APPLICATION NO.	FILING DATE	FIRST NAMED INVENTOR	ATTORNEY DOCKET NO.	CONFIRMATION NO.
10/723,389	11/25/2003	Thomas Redden Veariel	2003B103/2	8869
23455 7590 08/29/2008 EXXONMOBIL CHEMICAL COMPANY 5200 BAYWAY DRIVE P.O. BOX 2149 BAYTOWN, TX 77522-2149				
EXAMINER BODAWALA, DIMPLE N				
ART UNIT 1791		PAPER NUMBER		
MAIL DATE 08/29/2008		DELIVERY MODE PAPER

## **DETAILED ACTION**

### ***Response to Amendment***

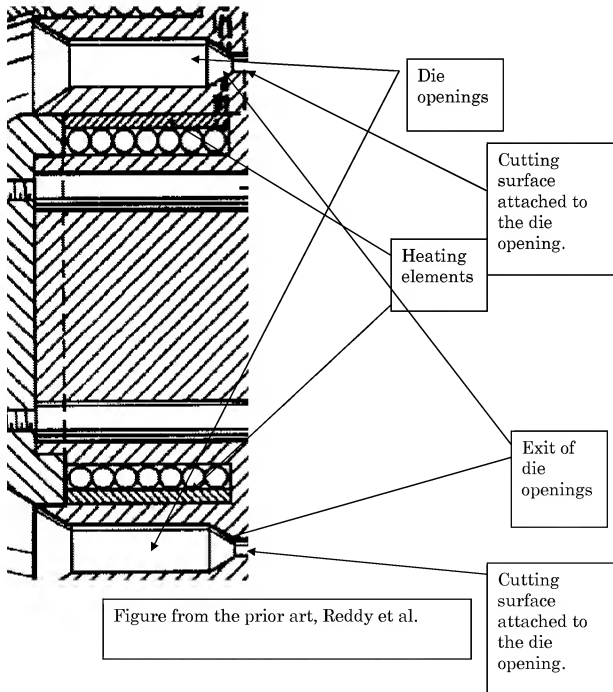
4. Applicant further argues that the prior art, Yoshida et al. (US 6,220,847) discloses a die having nozzle surrounded by the heat transfer channels, wherein prior art uses the term “periphery” for describing the position of the heater, not the phrase “proximate”.

5. Applicant’s argument is fully considered but not found persuasive because the prior art, Yoshida et al. (‘847) discloses underwater granulating die (2) which comprises die openings(7); and a heat transfer channel (8) formed in the periphery of the die and is provided in periphery of the opening (7) (See col.4 lines 33-36), wherein the periphery of the nozzle contains an exit point of nozzle and entrance point of nozzle, and, thus, inherently suggests that heating means is located near or at the downstream opening as cited in the claims of the instant application. (“Periphery” means boundary of an area). It further teaches that the high-temperature melted resin material extruded from the extruder, wherein the high-temperature melted resin is maintained the desired range of temperature with the help of heating means (8), which is located near the external surface of the opening (See col.5 lines 1-18; col.3 lines 41-46; and col.3 lines 55-56). If prior art discloses claimed structural limitation with the desired function, therefore, mere change in location of the structural limitation does not differentiate the function of the apparatus, and has no patentability weight, see *In re Japikse*,
